STAFF REPORT

City of Ormond Beach

SUBJECT: Pineland, Phase I, Preliminary Plat

NUMBER: 2015-084

Project No.: 4071.01 **Figure: 2**

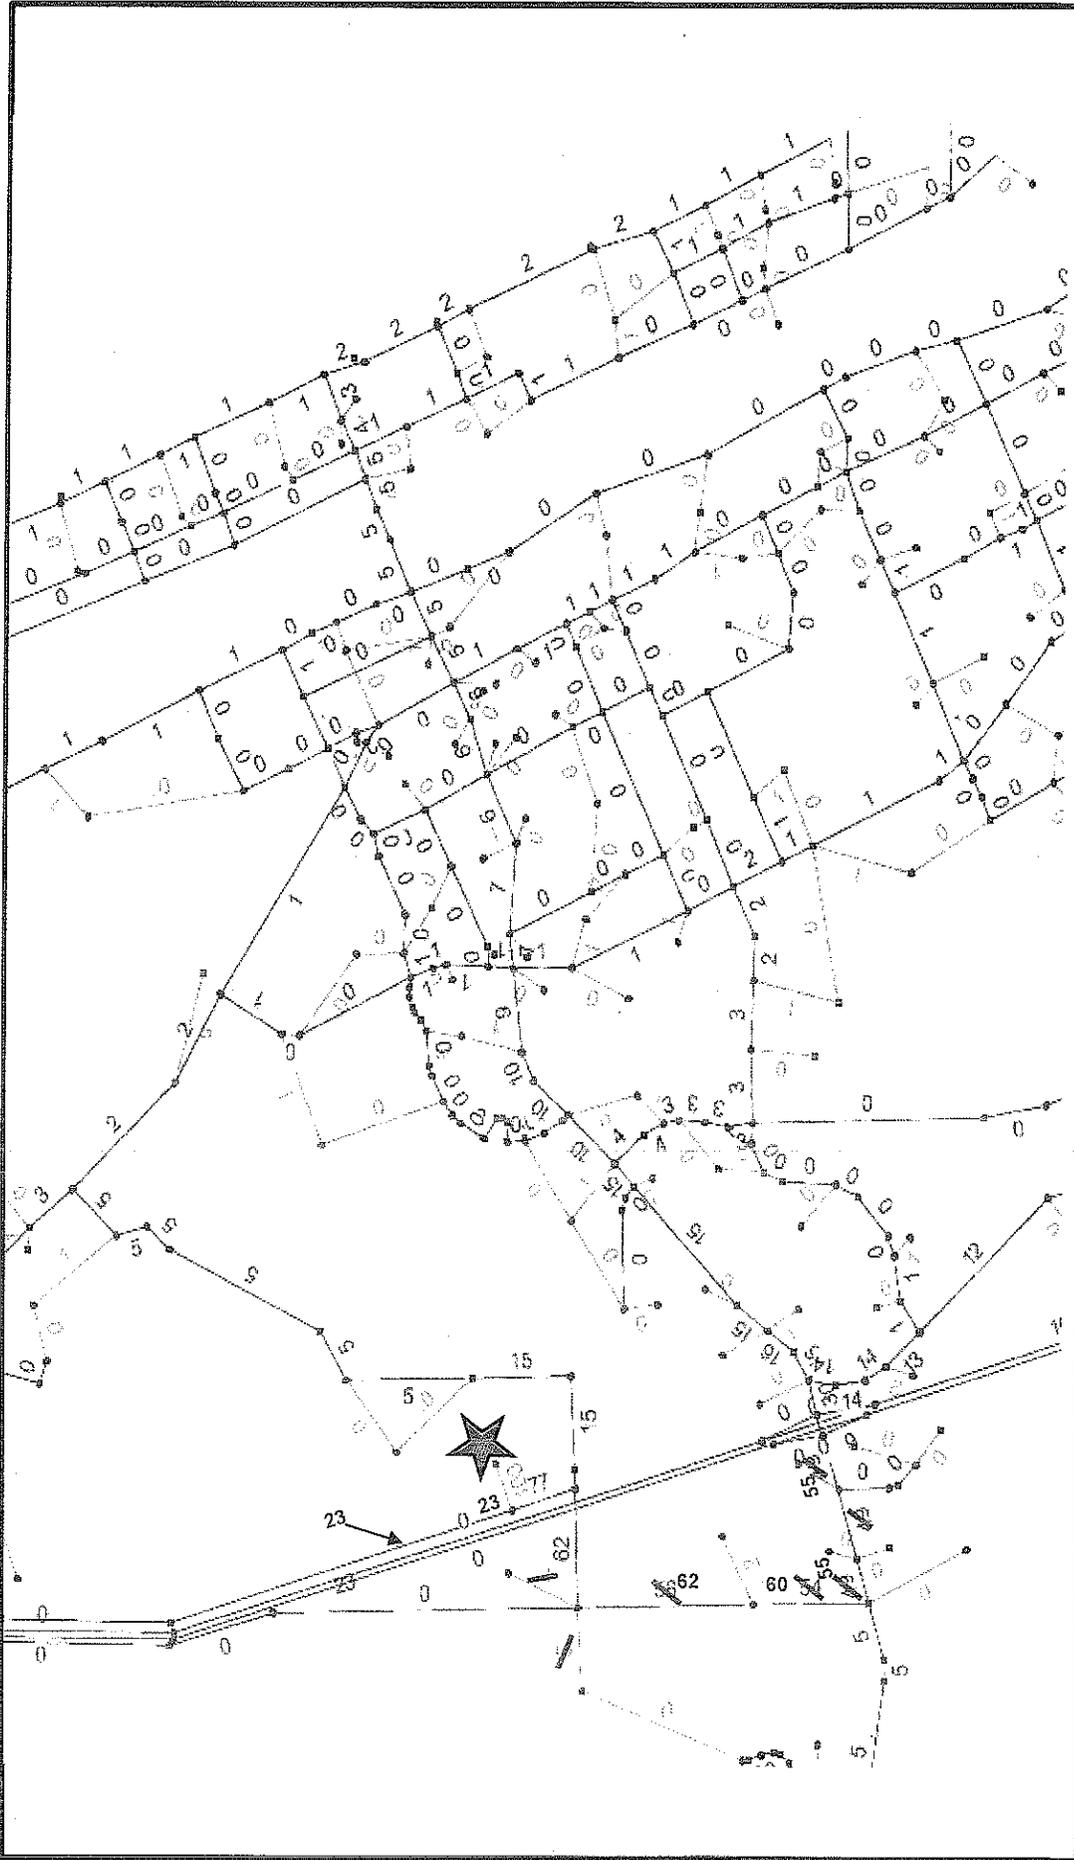
- 1.) Comment: Figure 2: Please manually adjust the trip distribution to be more realistic. For example, it is doubtful that 5% will travel on Airport Road west of Tymber Creek Road. Also, 10% will not likely be attracted to the Ormond Beach Airport, and one percent will not travel north on Tymber Creek Road north of Airport Road. Regarding the subdivision access, 100% of trips should be reflected on the segment of Pineland Trail between Harmony Avenue and Airport Road since none of the trips are traveling north on Pineland Trail.

Response: Manual modifications have been made to the distribution, as shown in Figure 2 of the Revised Methodology Letter. The five and one percent from west and north on Tymber Creek Road, respectively, have been redistributed to SR 40 between I-95 and Tymber Creek Road. While ten percent of development traffic may not be attracted to the Ormond Beach airport alone, it is reasonable to assume ten percent being attracted to development along this segment of Airport Road, which includes an elementary school. It should be noted that there is 23 percent of traffic to and from the north and 77 percent traffic to and from the south on Pineland Trail, for a total of 100 percent,
